Addendum No. 001

Subject: Mechanical Plant Replacement Bid Package
Mechanical
SDP Contract No. B-045 (c) of 2017/18

Location: Arts Academy at Benjamin Rush
11081 Knights Road
Philadelphia, Pennsylvania 19154

CHAIN LINK FENCE GATE DETAIL
NOT TO SCALE **2**

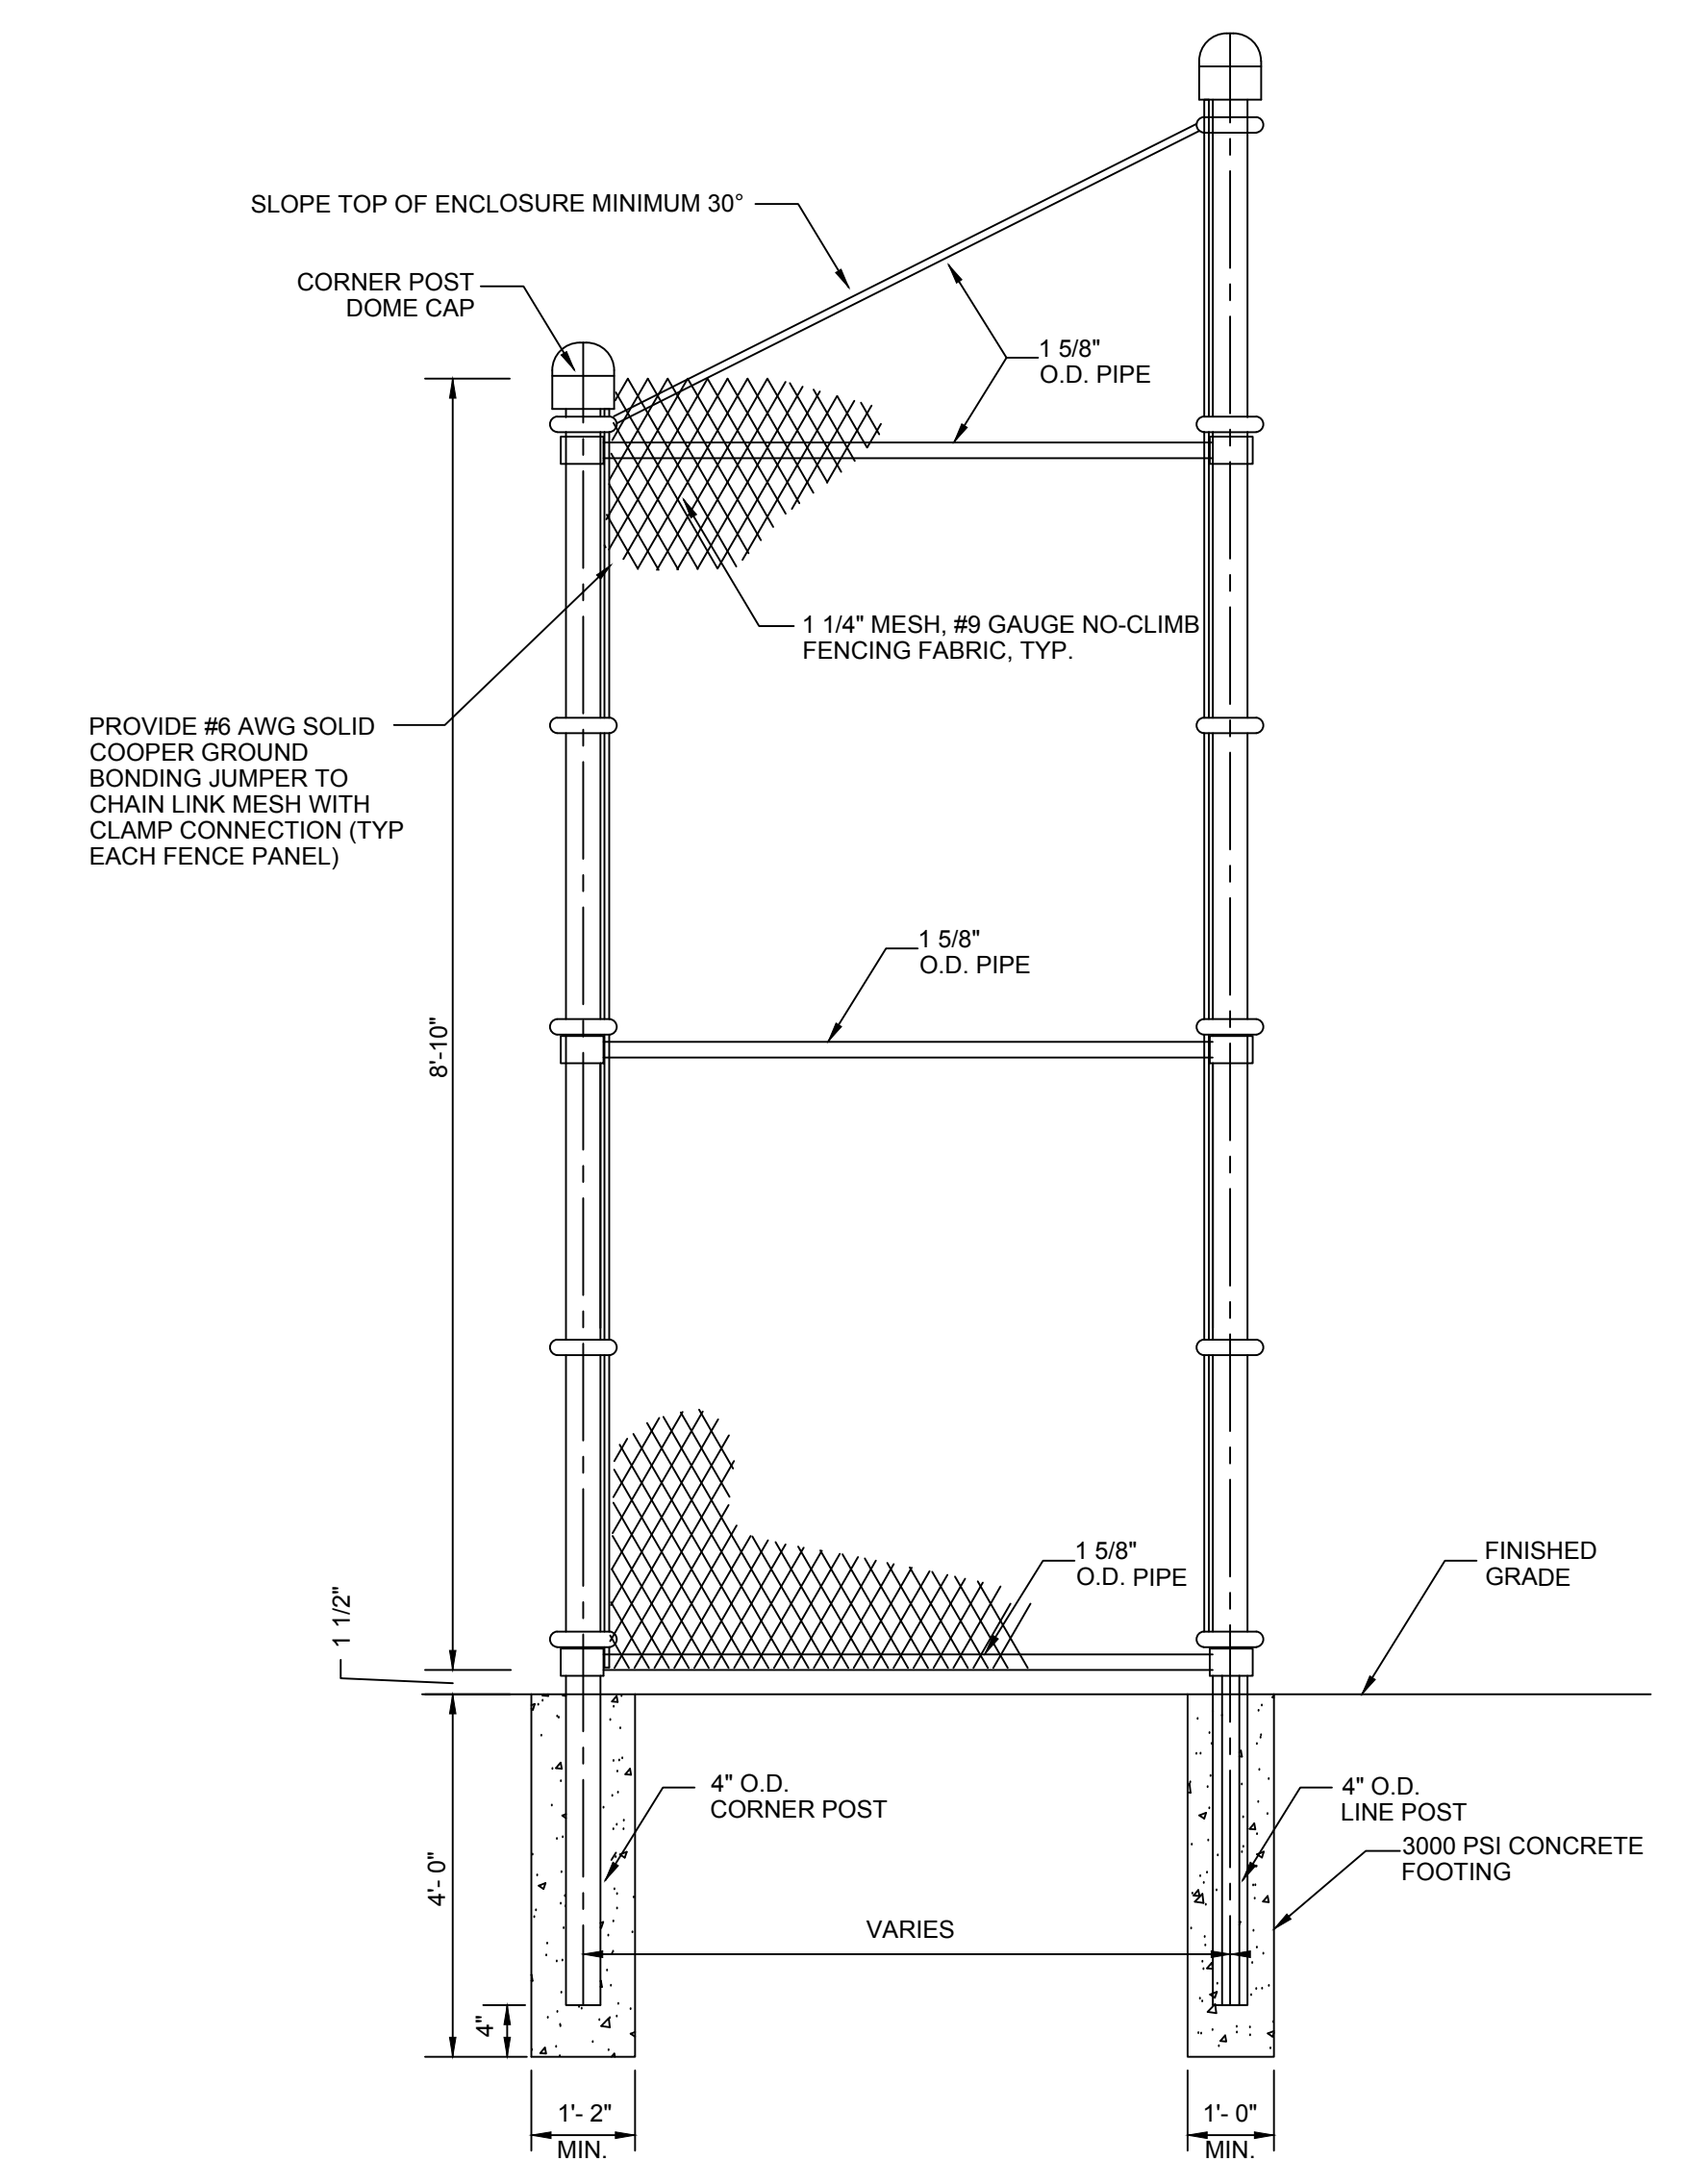
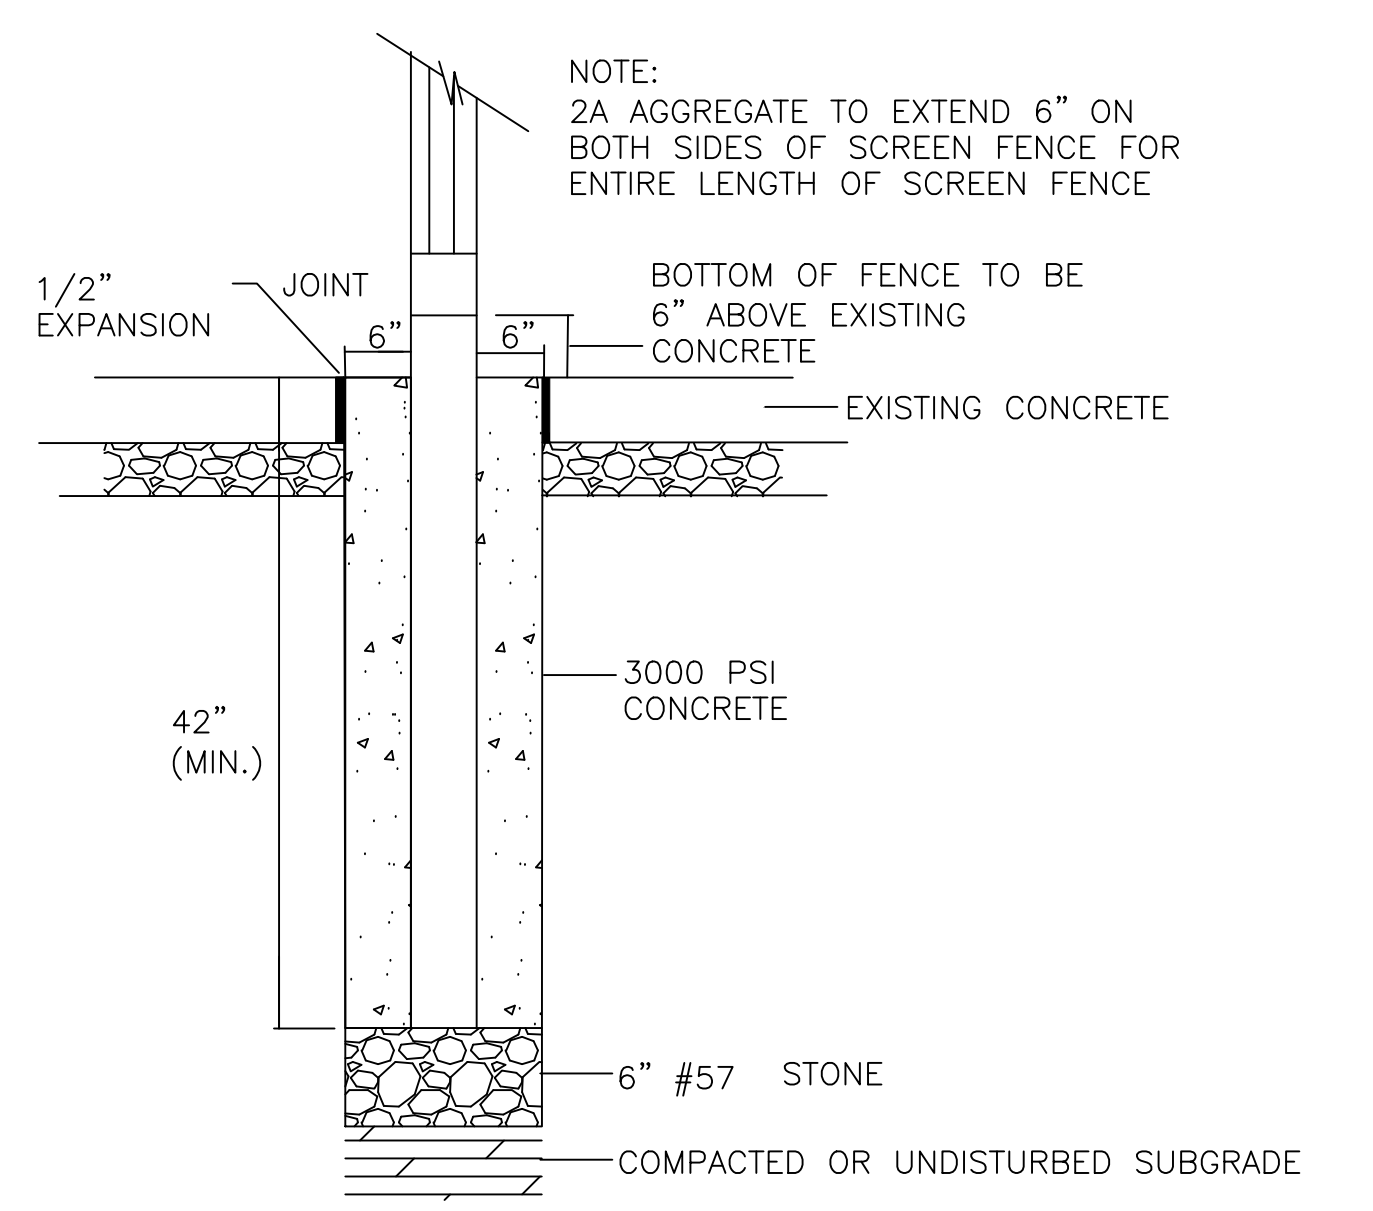
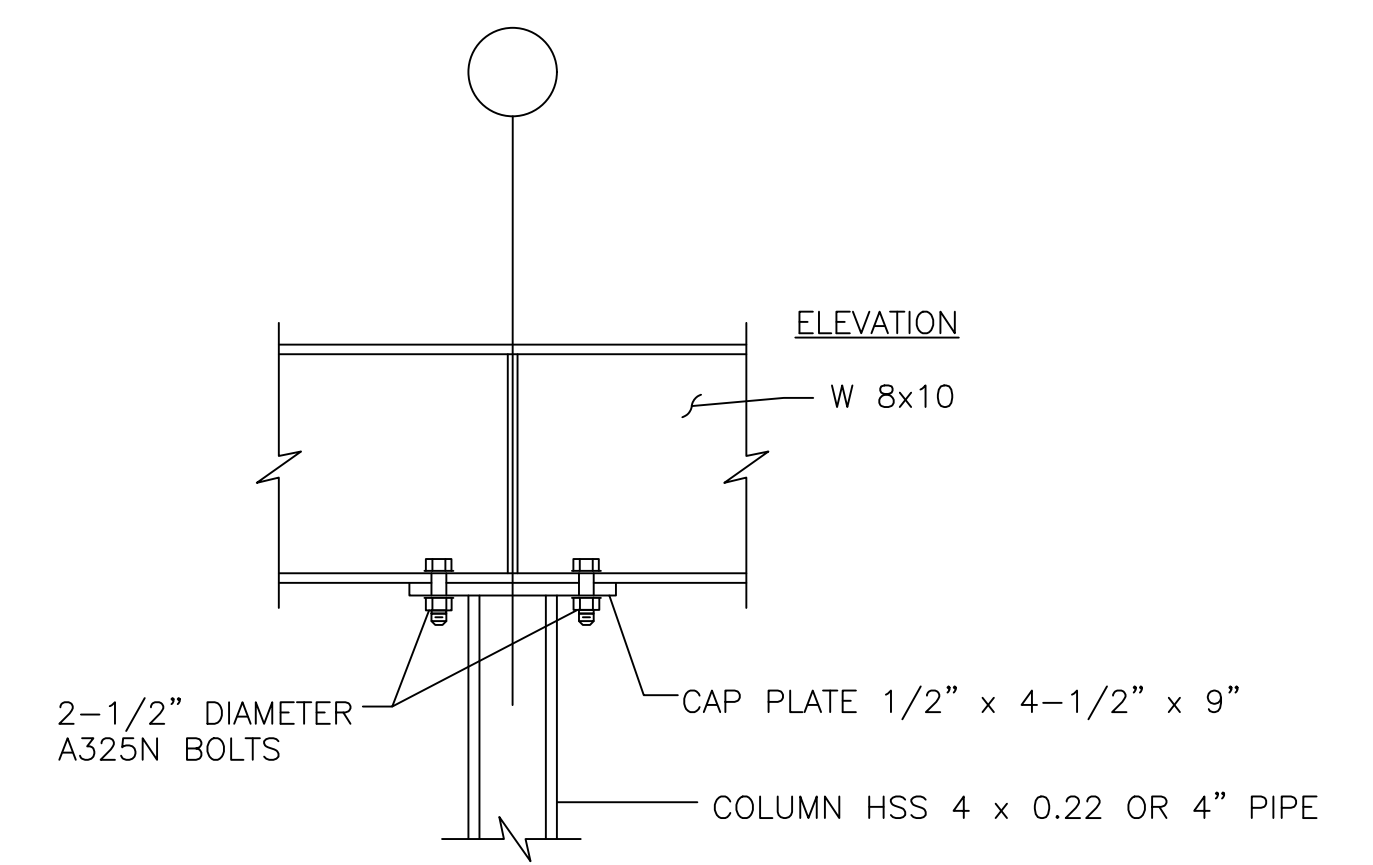
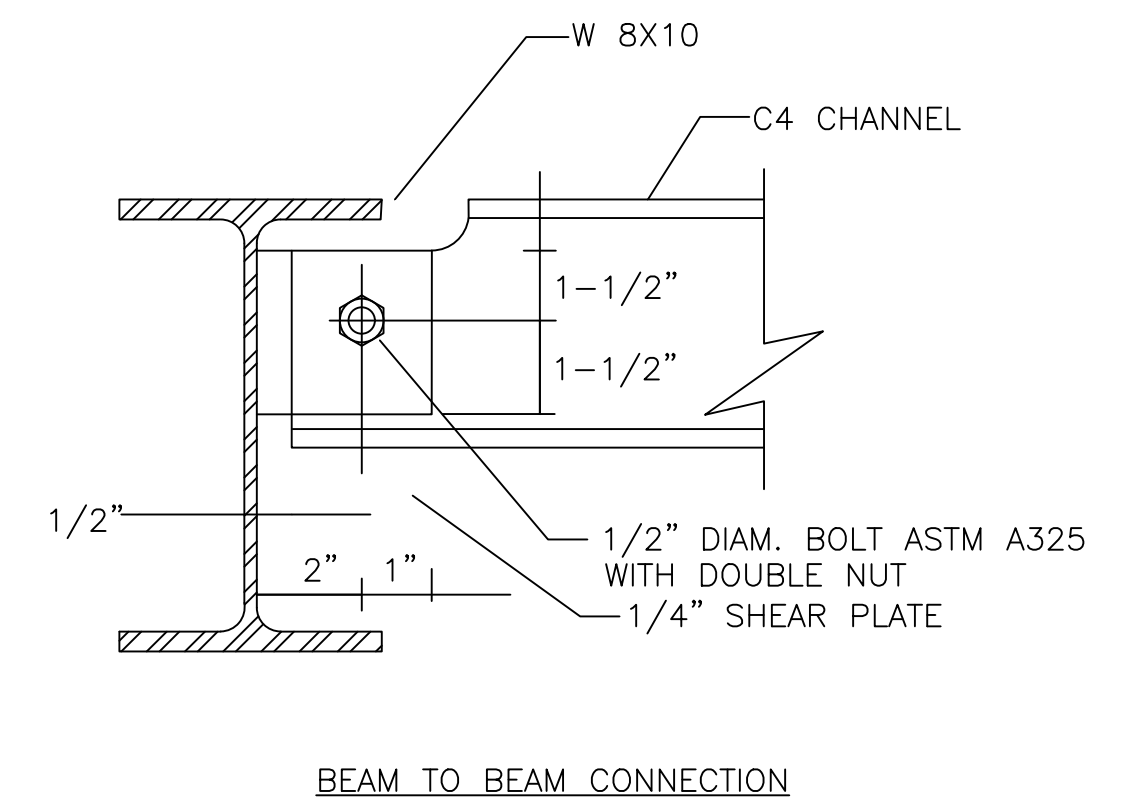
- 2.1.7** Added Sheet M501 – New detail sheet for chain link enclosure and bollard requirements.
- 2.1.8** Drawing revision E001 – Revised Life Safety Scope of Work Note 6 to indicate manufacturer of Fire Alarm system.

- NOTES:**
- ENCLOSURE HEIGHT TO BE 8'-10" TO TOP OF STEEL.
 - VERIFY ALL BUILDING DIMENSIONS PRIOR TO FABRICATION.
 - ALL ENCLOSURE MEMBERS TO BE GALVANIZED.
 - ATTACH CHAIN LINK FABRIC WITH GALVANIZED WIRE TIES 9" O.C. TO STRUCTURAL STEEL (FIELD DRILL).
